Prairie Island Nuclear Generating Plant Units 1 and 2
Dockets 50-282 and 50-306
License Nos. DPR-42 and DPR-60

Supplement to License Amendment Request (LAR) to Revise the Loss of Coolant Accident (LOCA) and Main Steam Line Break (MSLB) Accident Dose Consequences Analyses and Affected Technical Specifications (TS) (TAC Nos. MD9140, MD9141)

Enclosure 1

Attachment 1 **Prairie Island General Arrangement Drawing Showing Release/Receptor Combinations**

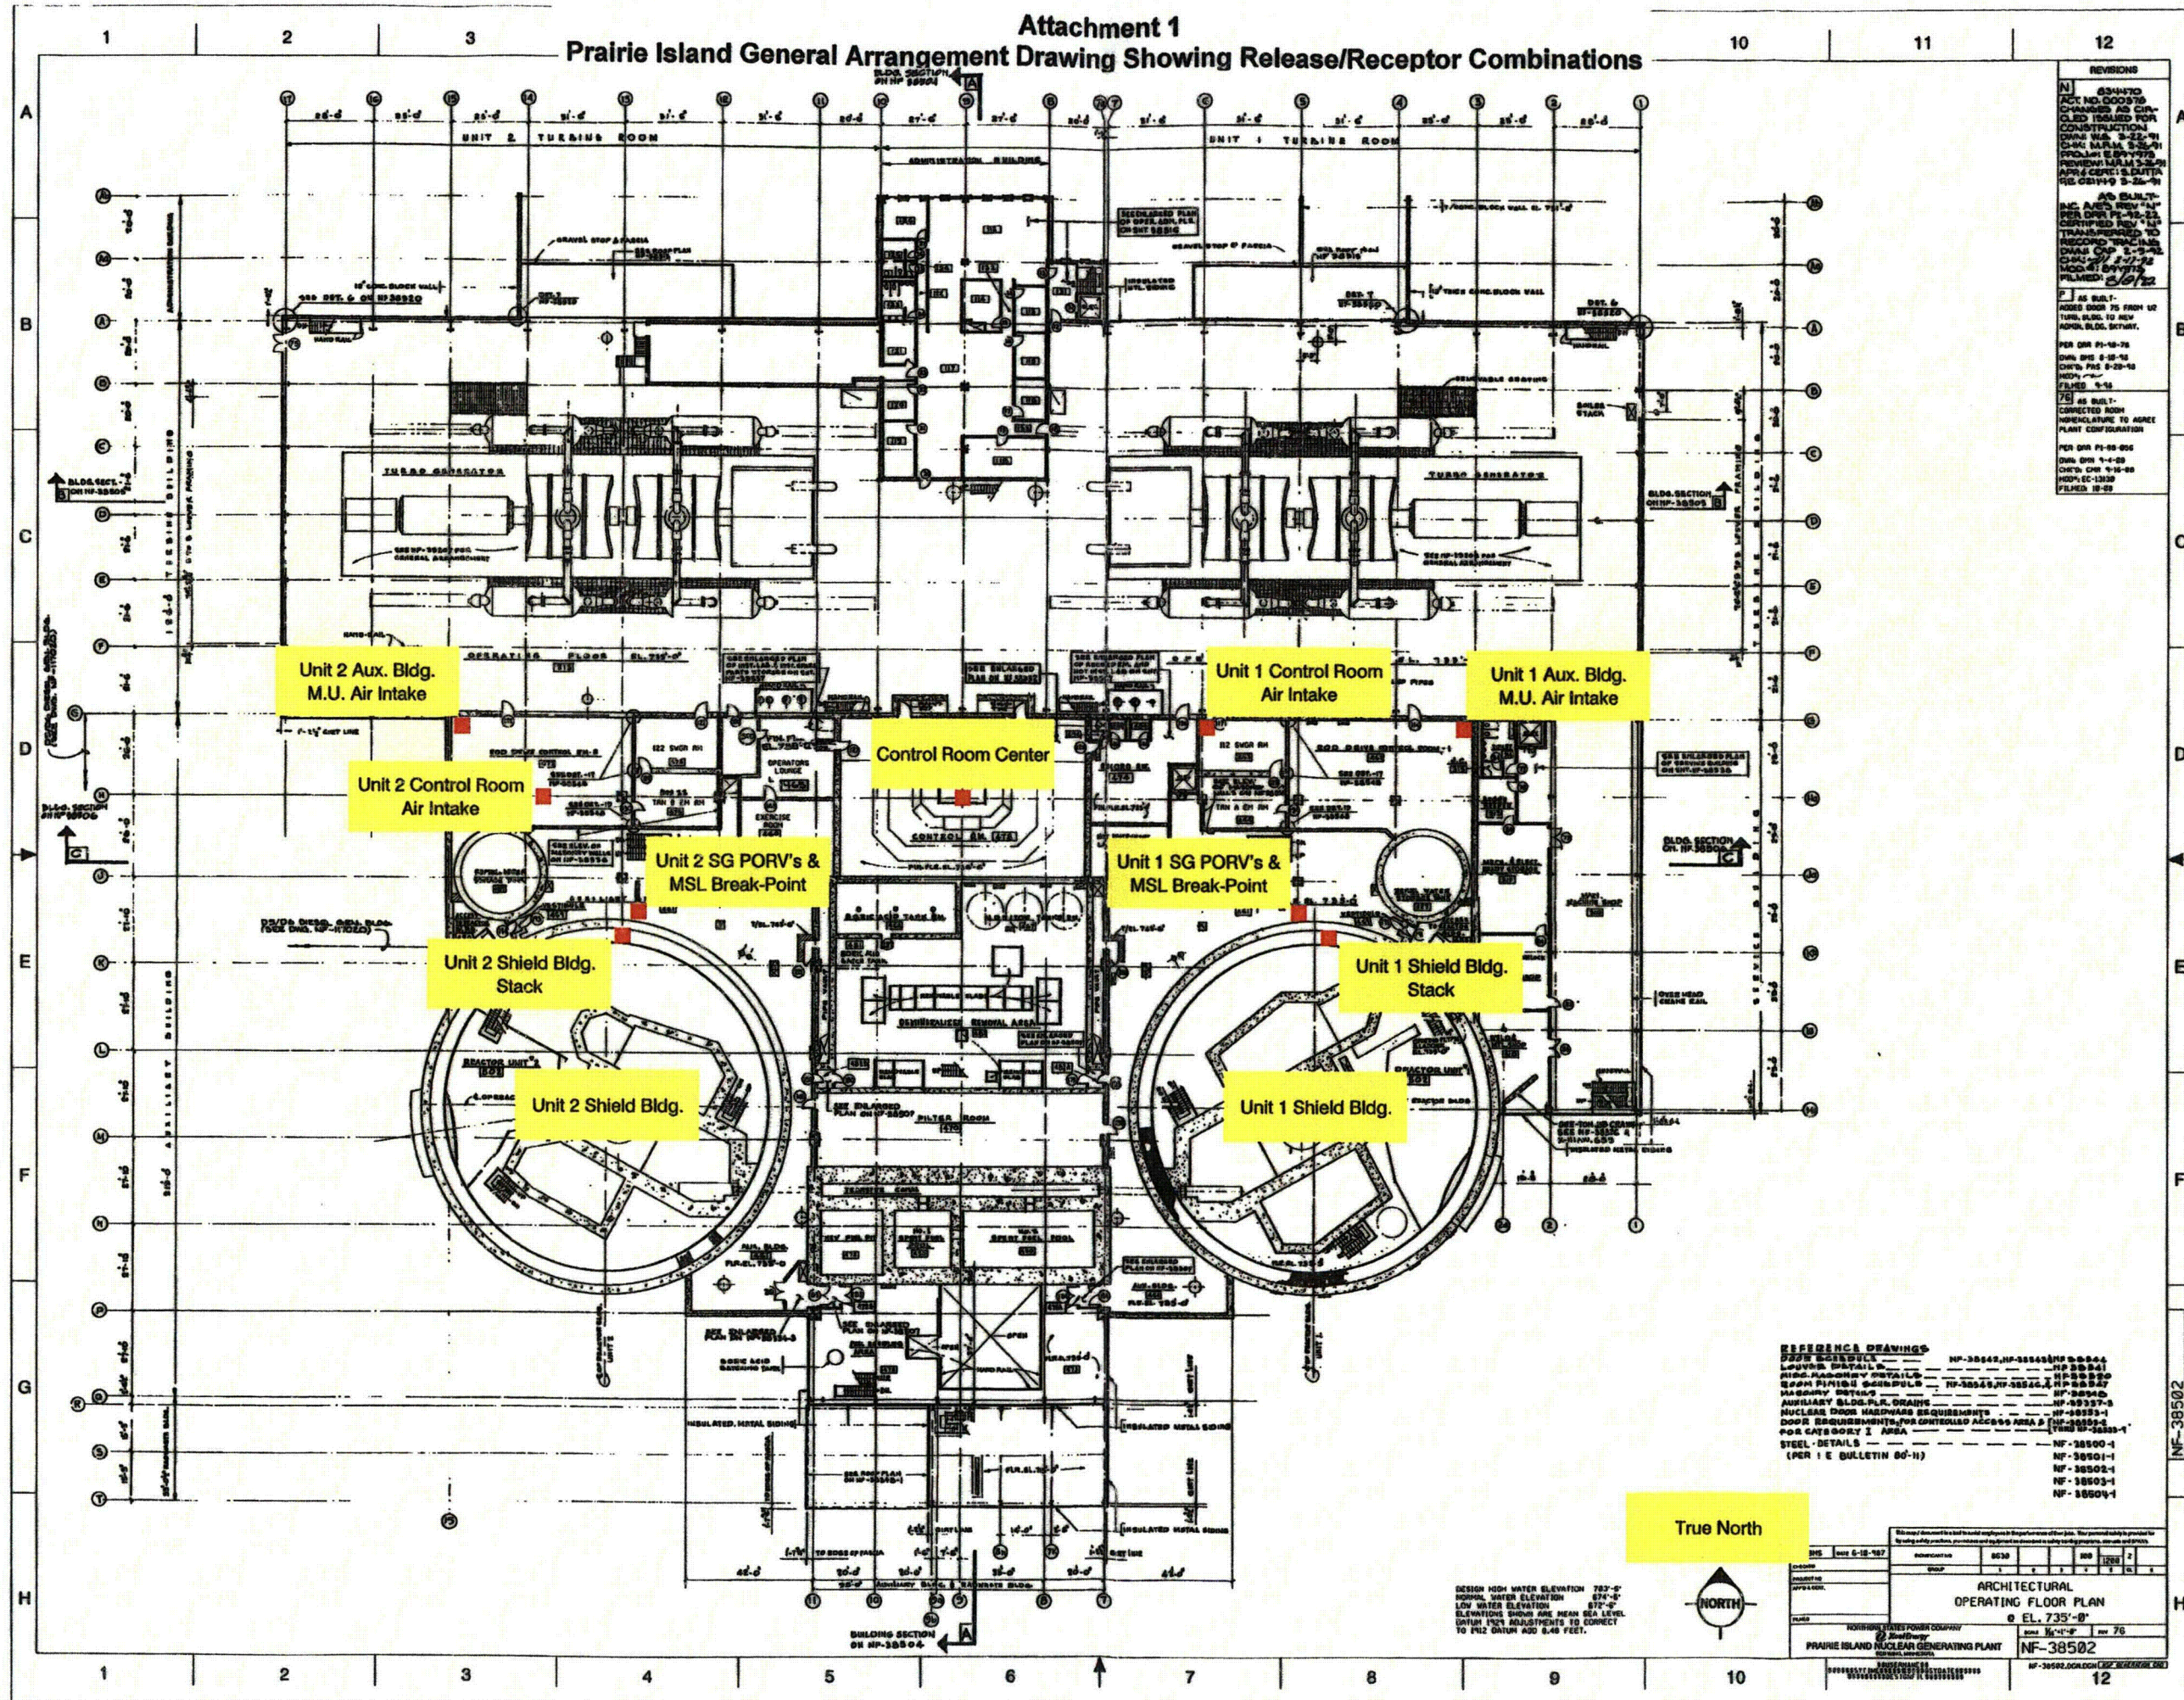
- b. Provide figures which support the selection of the inputs and assumptions used to calculate all of the onsite χ/Q values. Include a figure of the general arrangement of plant structures, drawn approximately to scale and showing true north, sufficient to enable the NRC staff to make confirmatory estimates of the selected inputs and assumptions and resultant χ/Q values for both the LOCA and MSLB accident. For each accident, highlight the postulated release and receptor locations including control room locations that may experience unfiltered leakage.**

- 1b. The PINGP plot plan, showing the general arrangement of plant structures, true north, and the postulated release and receptor locations, including the Control Room location that represents the receptor for unfiltered in-leakage, is provided in Attachment 1 to this enclosure. See response to NRC RAI No. 2 below for further detail regarding accident-specific release point and receptor locations.
- 1c. Distance inputs to the ARCON96 calculations were based on measured horizontal straight line distances based on the plant general arrangement drawing provided in the response to Item 1b.
